Charles Pople
Reliability Panel
Australian Energy Market Commission

AEC Submission to Frequency Operating Standard Draft Determination

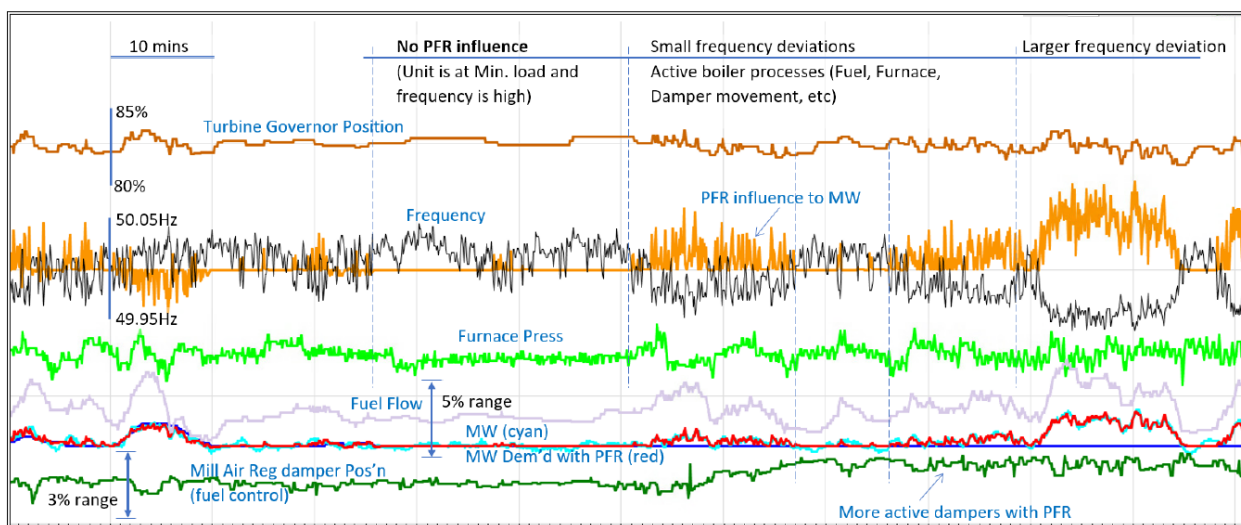
Steam turbines are experiencing considerable costs, wear and loss of thermal efficiency in caused by the numerous small movements required to support the current PFCB which Provecta consider to have been underestimated. Figure 7 (reproduced below) is real data drawn from a large NEM unit as it moves up from a minimum load point at the middle of the graph. Whilst at minimum load (a period when the frequency was above 50.00Hz) the unit was stable (as mandatory PFR does not require footroom). However upon moving up from minimum load, MW output varies continuously with frequency, and as a result, many mechanical parts of the Reg unit are also moving.

Provecta is concerned that these real costs were not fully captured by GHD. Provecta took the view that even quite a small relaxation in deadband would likely materially lower them.
